Access Compliance Report Public Rights-of-Way (Curb Ramps)

Intersection ID: 10035683 Main Street: RED RUST LN **Cross Street: N/A** Location: SW ADA ID: 2A8D36B11B86 Ramp Type: Directional1 Initial Pass/Fail: Fail **Overall Compliance: No Severity Score:** 1.25

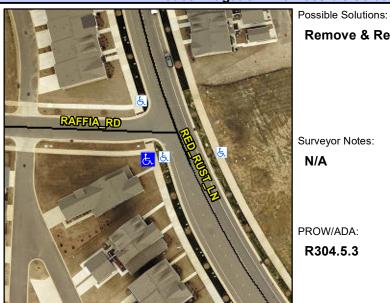
Field Measurements/Component Compliance					
Compliance Description		Data	Comp	liance Description	Data
N/A	Ramp Length (in)	79.0	N/A	Grade Break?	N/A
Yes	Ramp Width (in)	94.0	N/A	Grade Break Slope (%)	0.0
Yes	Ramp Slope (%)	6.7	N/A	Grade Break XSlope (%)	0.0
No	Ramp XSlope (%)	3.5			
N/A	Flare Type LT	N/A	N/A	Flare Type RT	N/A
N/A	Flare Slope LT (%)	N/A	N/A	Flare Slope RT (%)	0.0
N/A	Flare Traversable LT?	N/A	N/A	Flare Traversable RT?	N/A
N/A	Landing Length (in)	0.0	N/A	DWS Provided?	N/A
N/A	Landing Width (in)	0.0	N/A	DWS Contrast?	N/A
N/A	Landing Slope (%)	0.0	N/A	DWS Length (in)	N/A
N/A	Landing X Slope (%)	0.0	N/A	DWS Full Width?	N/A
N/A	Landing Curb? (Y/N)	N/A	N/A	DWS Offset LT (in)	N/A
N/A	Shared Landing?	N/A	N/A	DWS Offset RT (in)	N/A
N/A	Gutter Ponding?	0.0	N/A	Gutter Slope (%)	N/A
N/A	Gutter Lip Ht (in)	0.0	N/A	Gutter X Slope (%)	N/A
N/A	Painted X Walk1?	No		Road Slope (%)	1.4
	X Walk 1 Direction	To N		Road X Slope (%)	1.4

Remove & Replace Entire Ramp. Surveyor Notes: N/A PROW/ADA: R304.5.3
